Construction Documents

RFI's

Subject: RFI 64 - Joint Seal at CIP Retaining Wall

RFI Number: R-AW0104

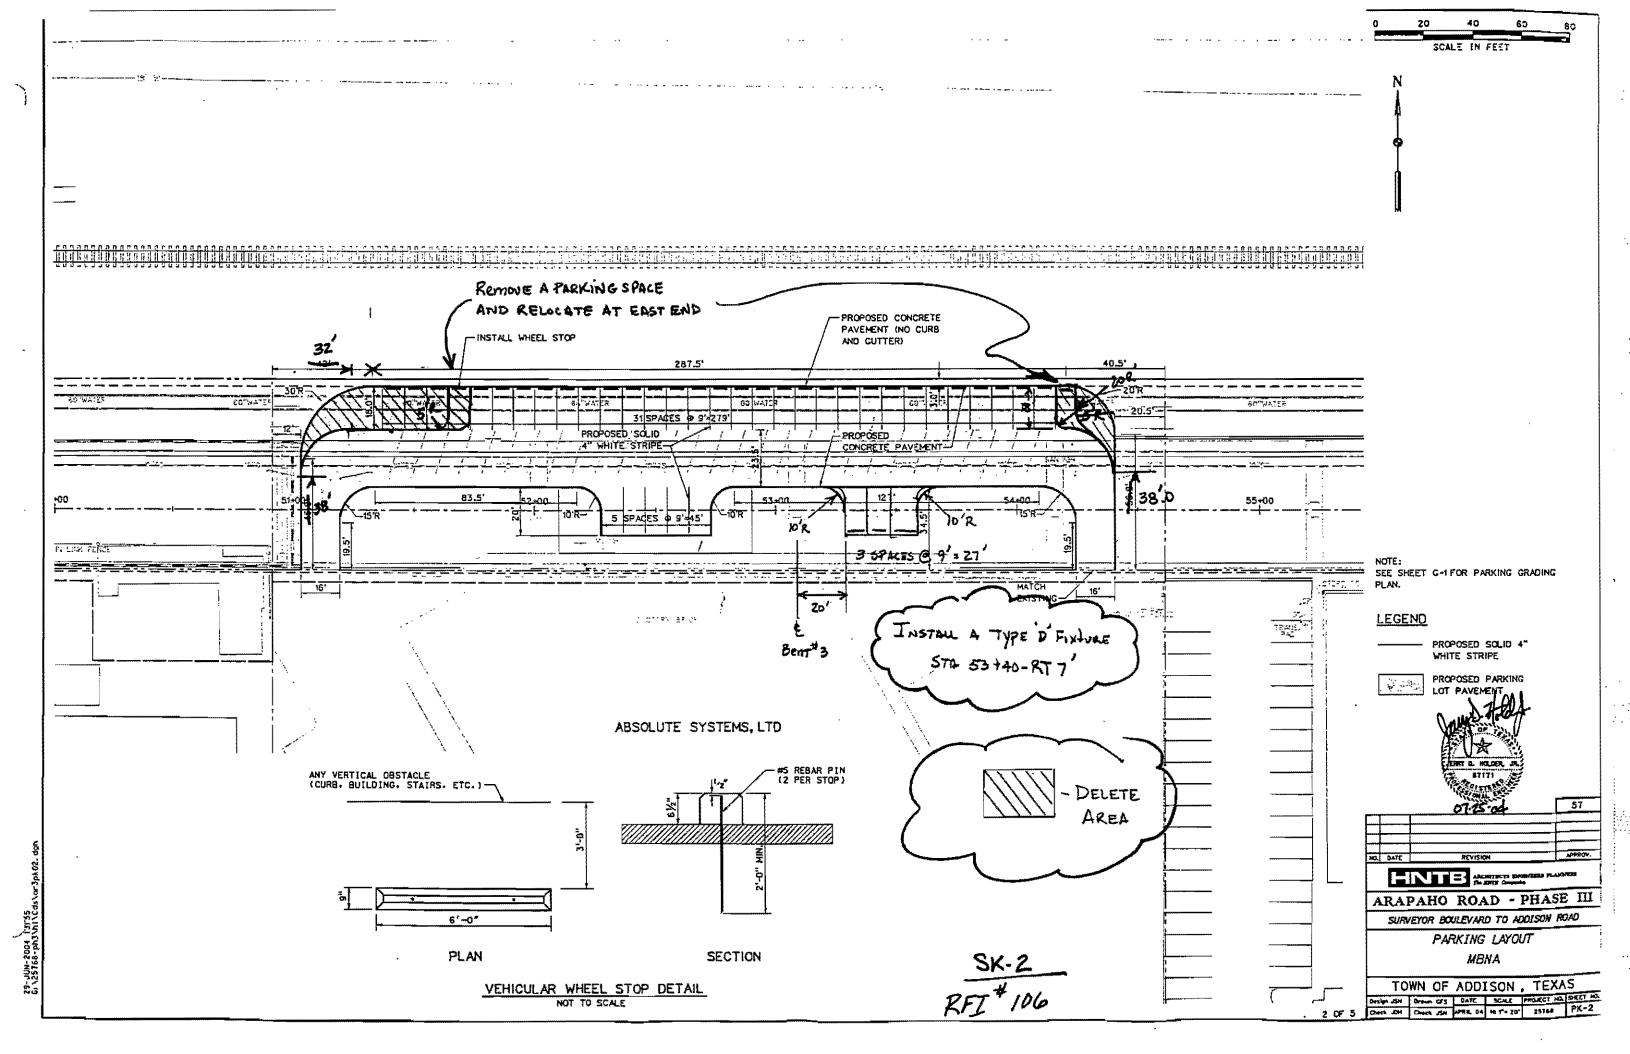
Archer Western has received and reviewed grades for the Addison road parking lot and discovered the parking lot will still hold water in one corner. The pipe and inlet are already installed. Please review the attached information and provide Archer Western with a solution.

In response to your RFI #104, Please find attached a sketch showing the raise the top of curb and gutter at the Northwest corner of the future Addison Parking Lot. See attached sketch SK-1

RFI 109

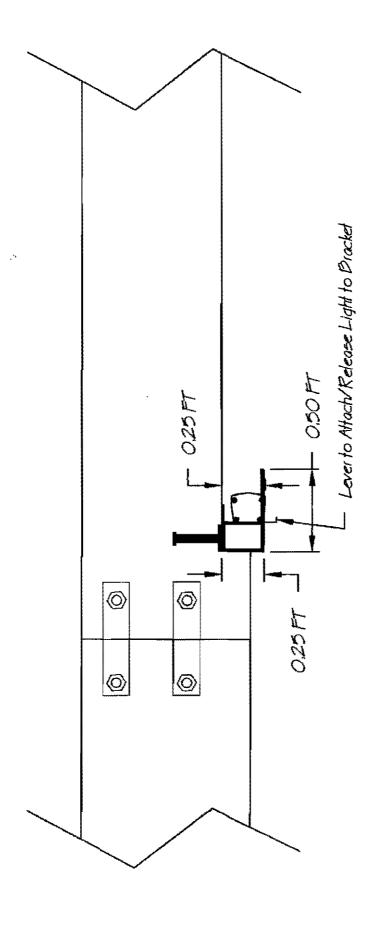
Proposed Type C1 Lights Configuration $S_{KErcH}Z$

RF1 109

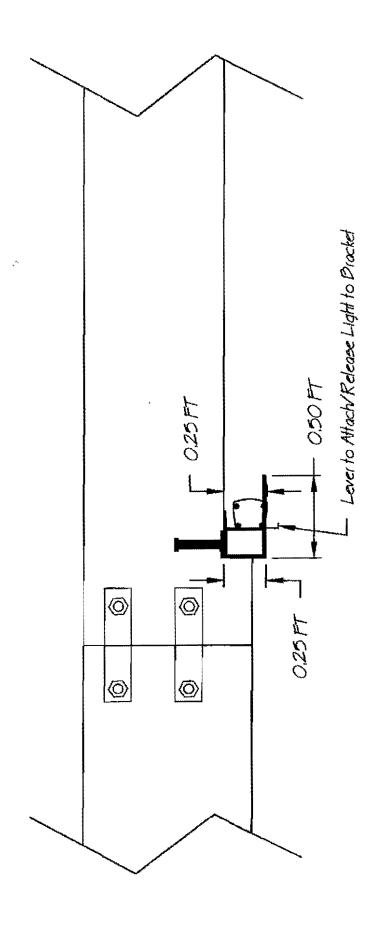
Proposed Type C1 Lights Configuration $S_{KE}r_{c}\#Z$

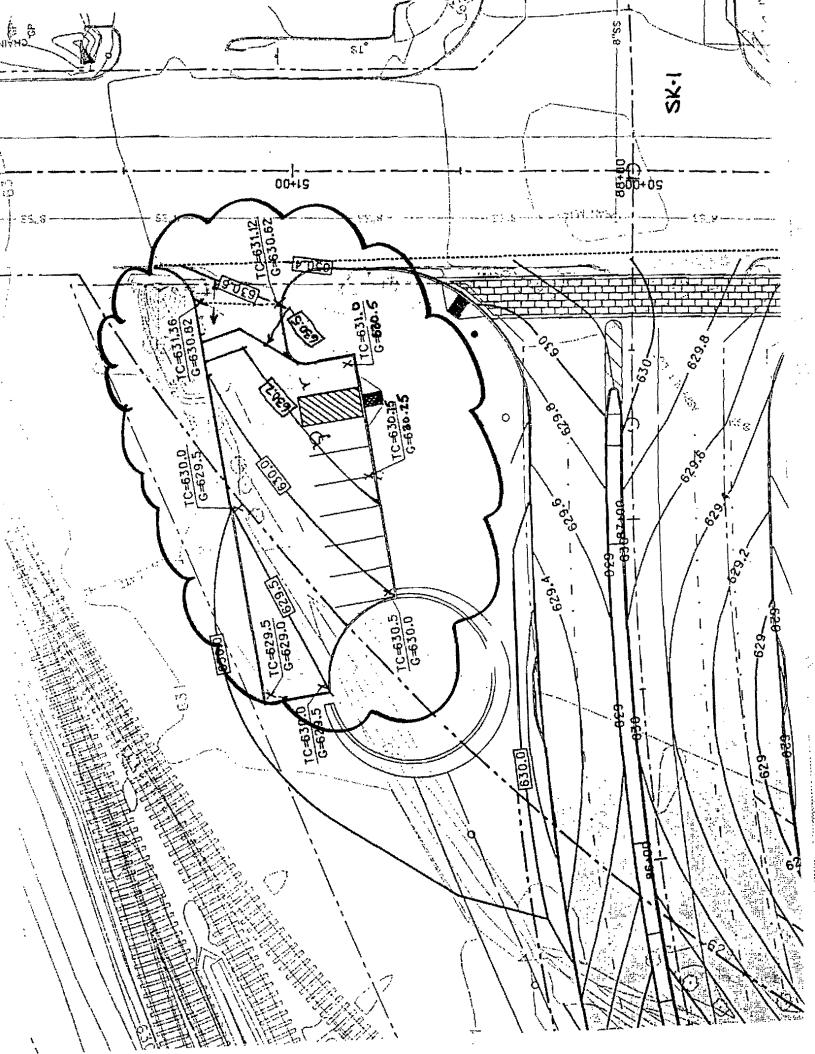
Sheet 64 of the Plans shows the Addison Parking lot Grading Plan to have two "Low Points" which are located in the Northwest Corner and in the middle of the South Edge to drain this parking lot. (See attached Sheet) According to Sheet 106 of the Plans, there is an inlet in the southwest Corner just north of the Landscape Mound. (See attached Sheet) The grades shown on Sheet 64 appear to create two "ponds" that will not drain toward this Inlet C-7 shown on Sheet 106.

To eliminate the low points along the South edge of the parking lot, Please find the attach sketch with new grades and contours for the east half of the Parking Lot off of Addison Road which is found on the Sheet G-4, page 64.

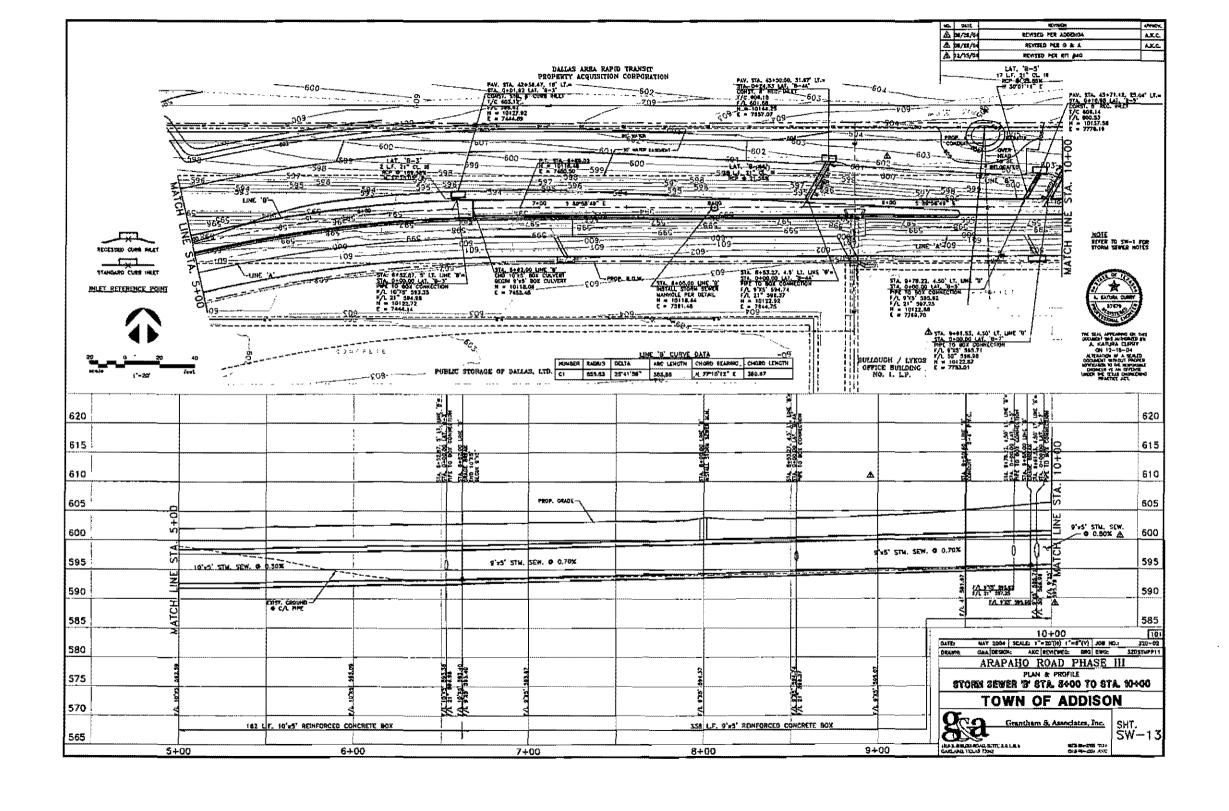
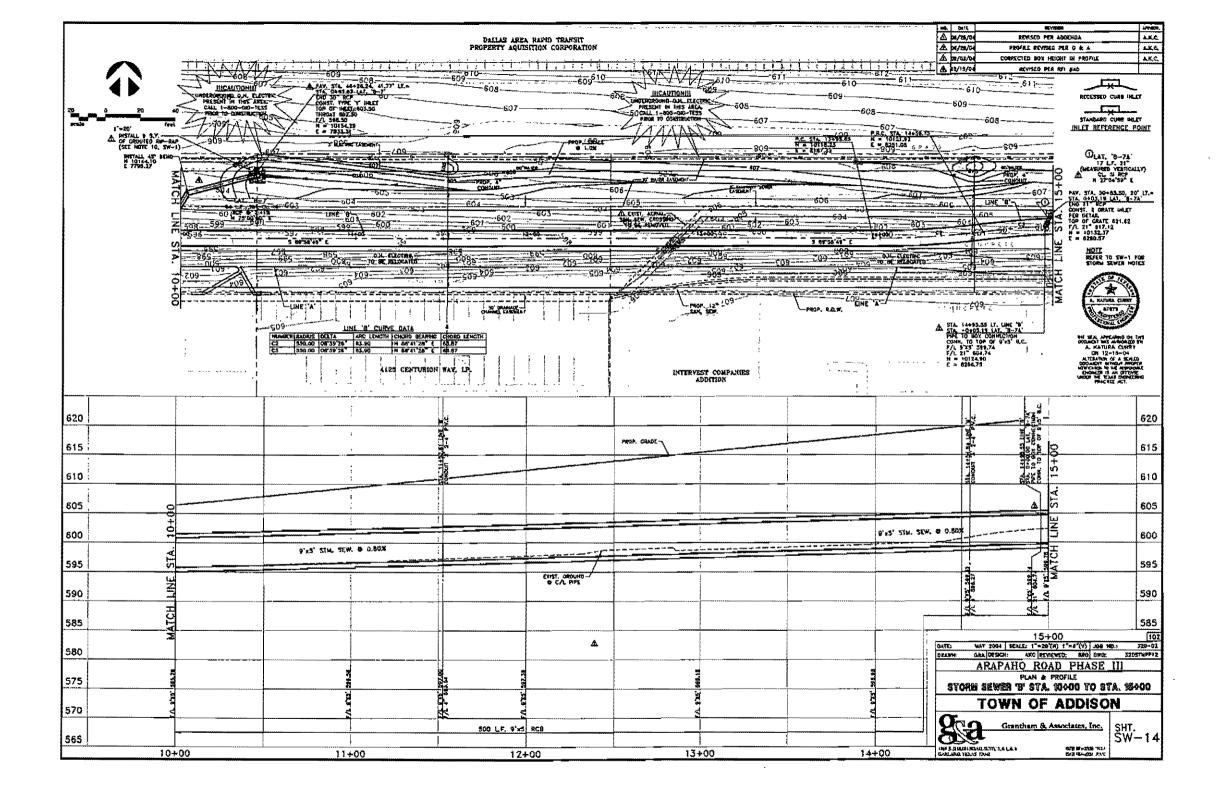
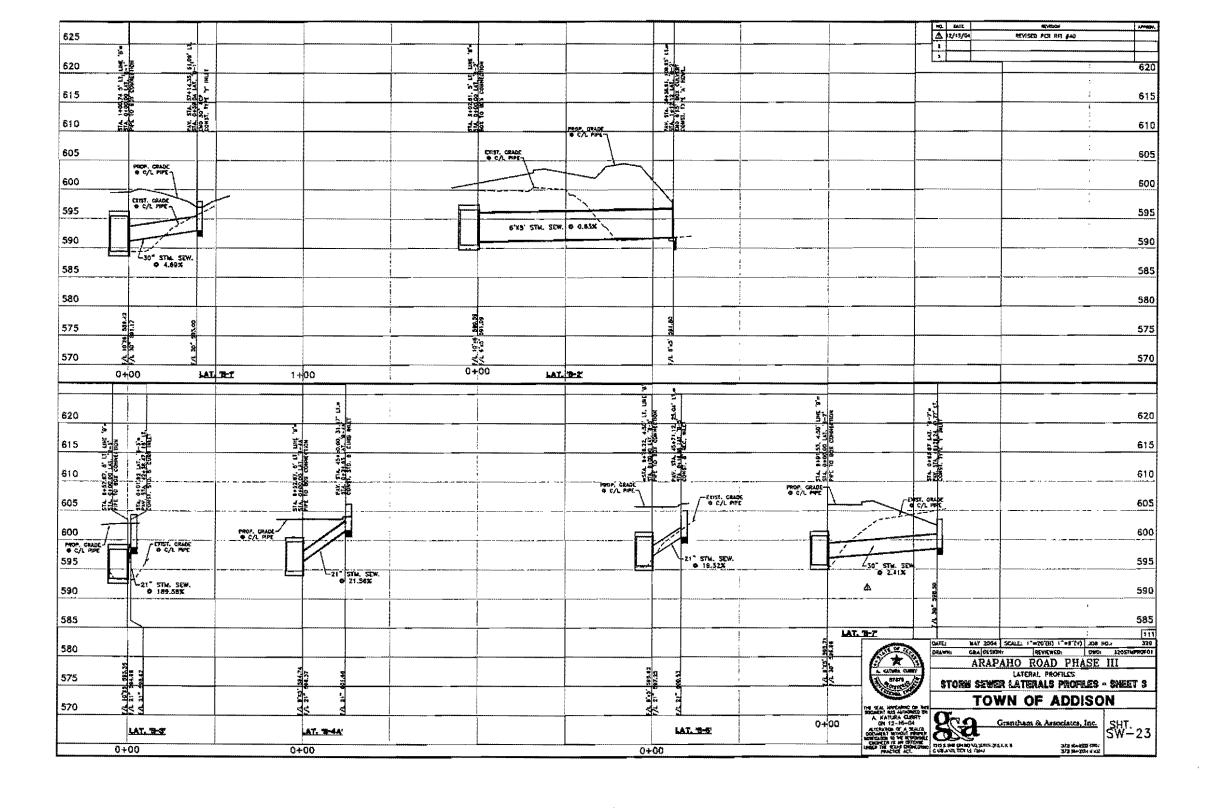
- 1. The Station and Offset given on sheet 102 (Sta 45+07.54, 35.28LT) for inlet B-7 does not match the coordinate information given. The coordinate information given put the in inlet at Station 46+27.74, 40.27LT. Please advise where the inlet is to be located.
- 2. If the coordinate information is correct, then the inlet will be in conflict with the existing DWU 60" waterline. Per the pot hole information provided by HNTB.
- 3. If the coordinate information is correct, then lateral B-7 will be in conflict with the retaining wall #1 trench footing which starts at station 46+00.

Attached to this response are three contract drawing that will be official issue to Archer Western Contractors, Ltd. for lateral B-7 pipe and inlet along the Storm Sewer "B"-line. The information included on the plans should answer all questions above.
